Agenda Title: For Possible Action: To consider a request from Capstone Communities for Tentative Subdivision Map known as Arbor Villas, consisting of 147 single family attached residential lots on property zoned Multi-Family Apartment (MFA), located on Little Lane, APN 004-021-13. (Hope Sullivan, hsullivan@carson.org)

I move to approve TSM-16-023, a Tentative Subdivision Map known as Arbor Villas, consisting of 147 single family attached residential lots on property zoned Multi-Family Apartment (MFA), located on Little Lane, APN 004-021-13, based on the ability to make the required findings in the affirmative and subject to the conditions of approval contained in the Memorandum dated June 1, 2016 from the Planning Manager to the Board of Supervisors.

MEMORANDUM

TO: Planning Commission **Item F-1A & F-1B**

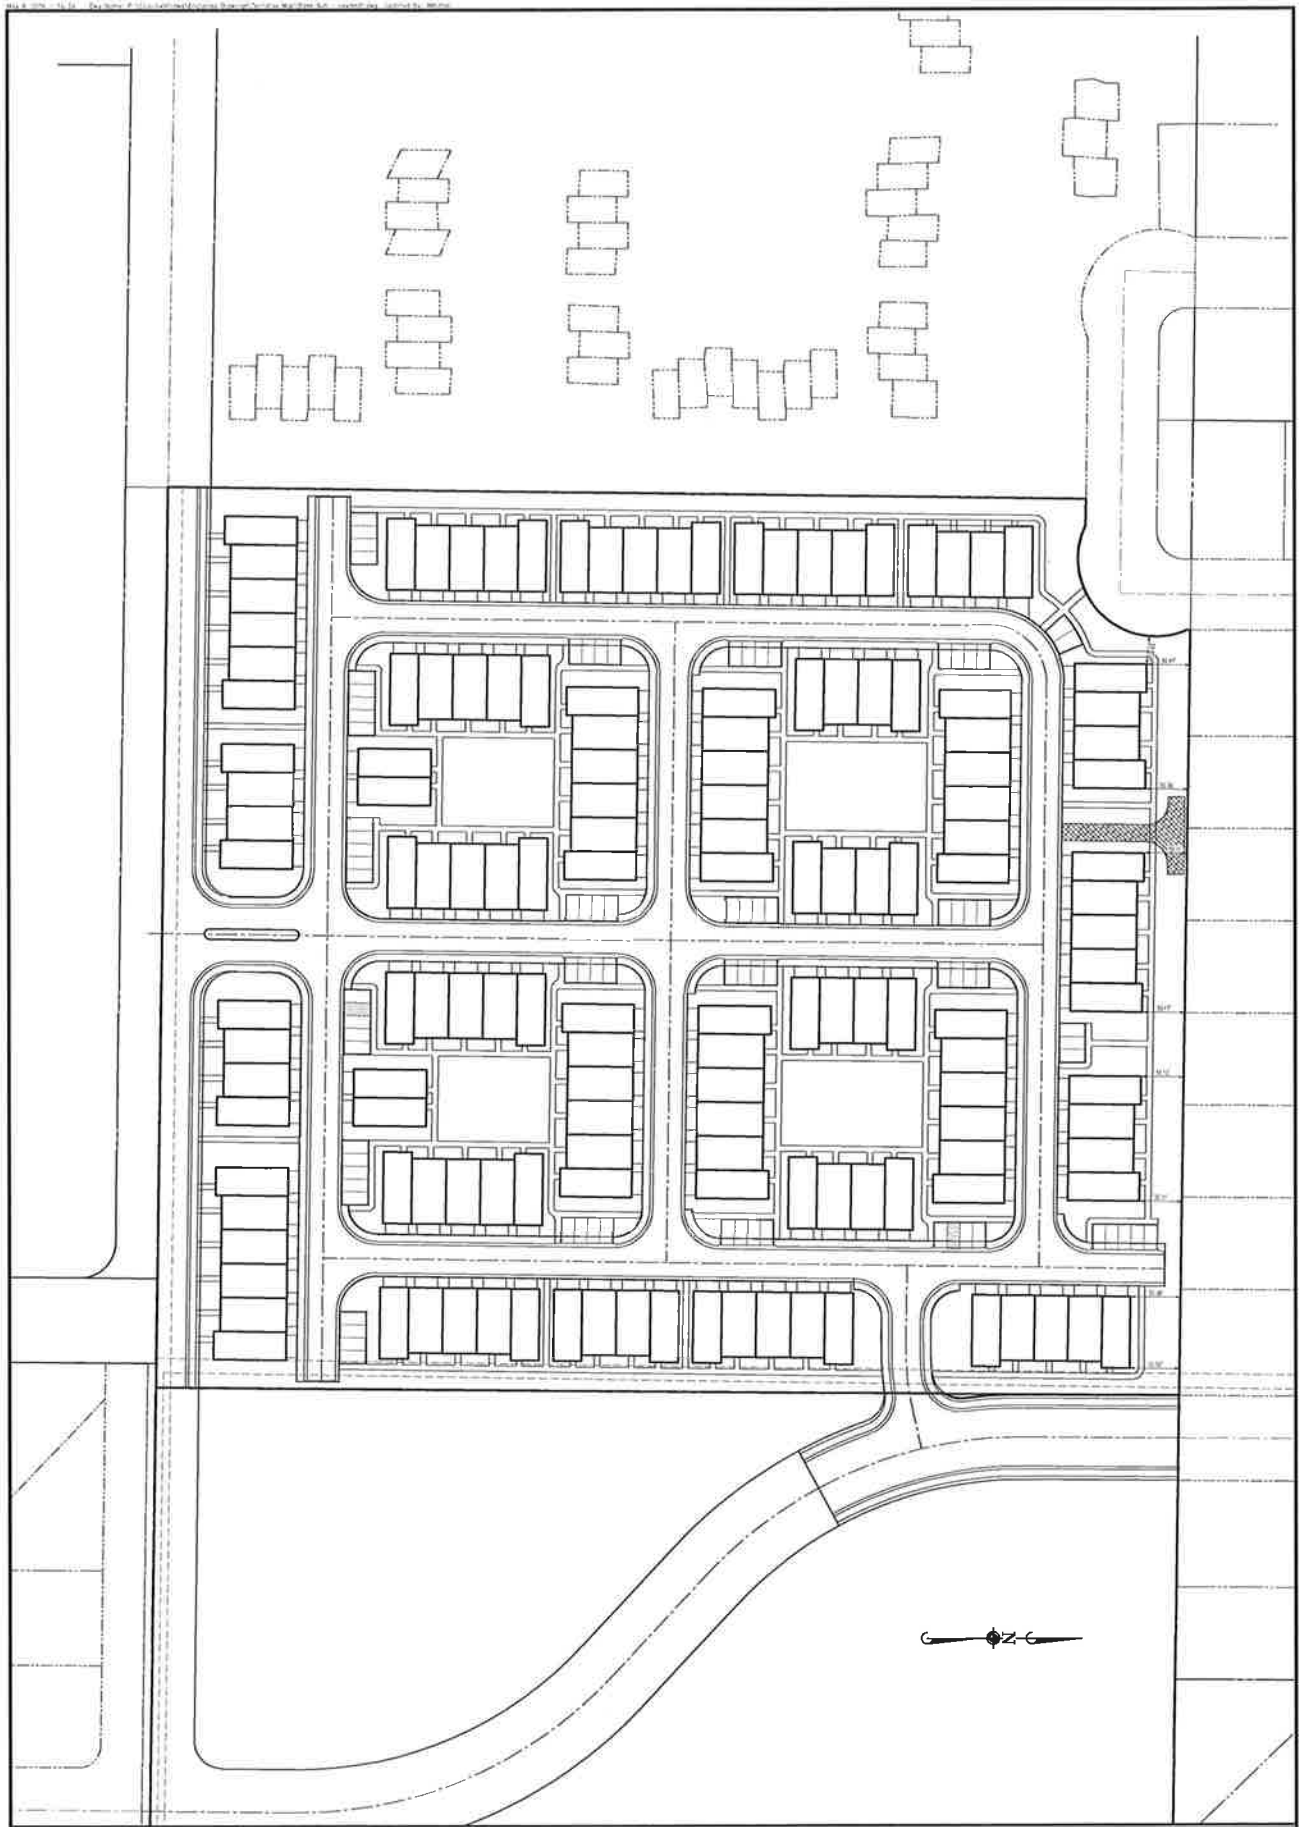
The applicant has revised the site plan to comply with the Fire District's required turning radii, and to comply with the required 30 foot rear setback. The applicant has also redesigned the site plan to provide visual relief between the buildings closest to the northern property line. Rather than 315 linear feet of building mass, the linear feet of building is reduced to approximately 290 linear feet.

Recognizing that architecture is not within the Commission's scope of review with respect to these applications, the applicant has submitted updated elevations and floor plans. Whereas the elevations indicate a balcony for each unit, the floor plans provide for some units with balconies and some without. Note on the floor plan the balcony is referred to as a covered deck.

VICINITY MAP TSM-16-023 & VAR-16-024

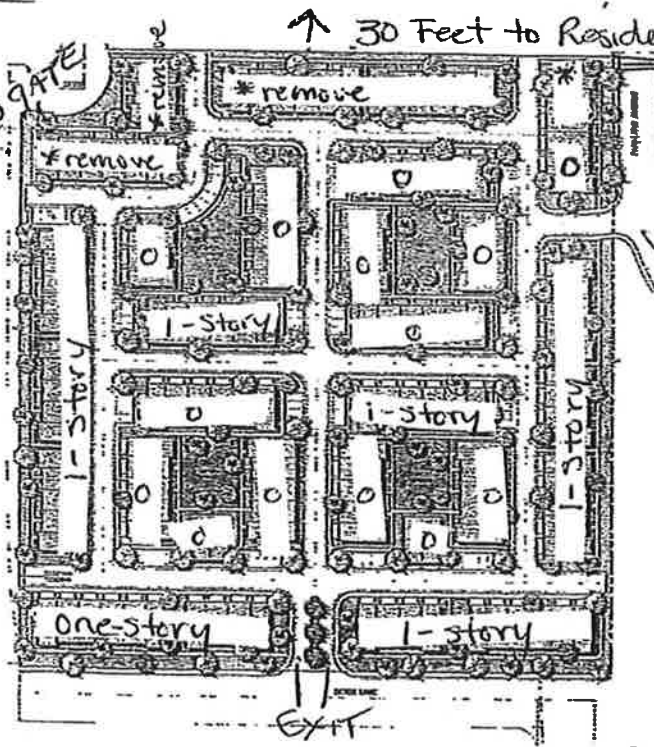
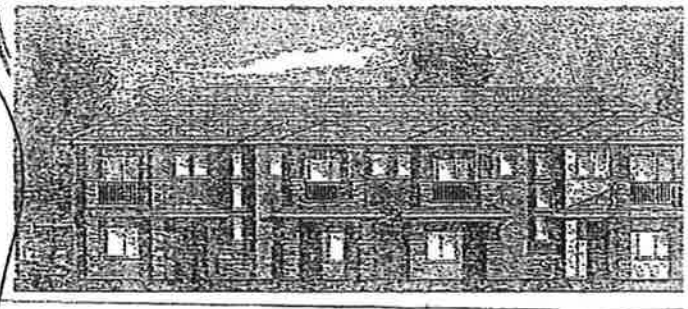
↑ 30 Feet to Residential

emergency exit only to 5th St
 2 Little Lane exits
 ∅ Parkland exits to 5th st.

* Remove 24 units
 ○ 1-story remaining in
 (71 - 1-story units)

exit

OPTION 2

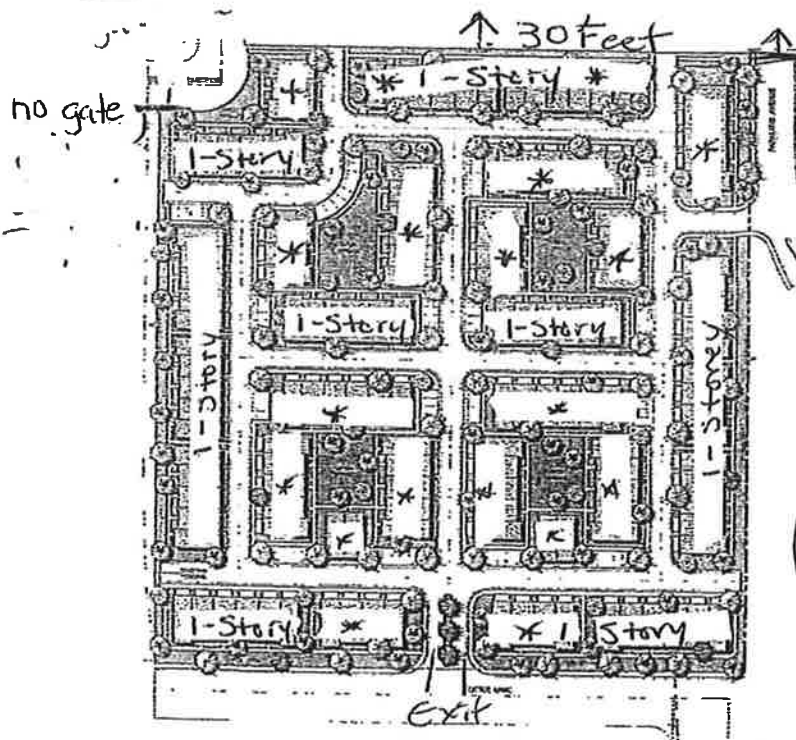
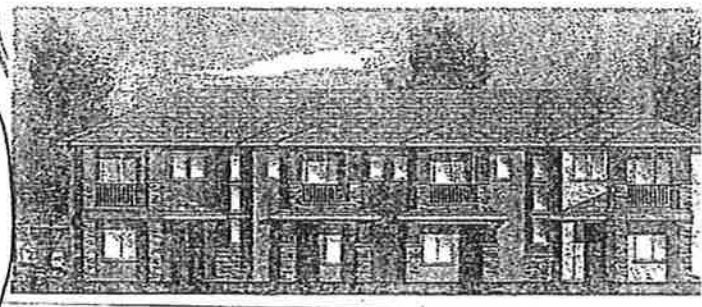
↑ 30 Feet
 ↑ emergency only
 2 little lane exits
 ∅ Parkland to 5th except emergency

All one-story *
 1/2 the units.
 ↓ exit 73 sf attached 1-story

ii. Blends 1 story housing with existing residential. 31
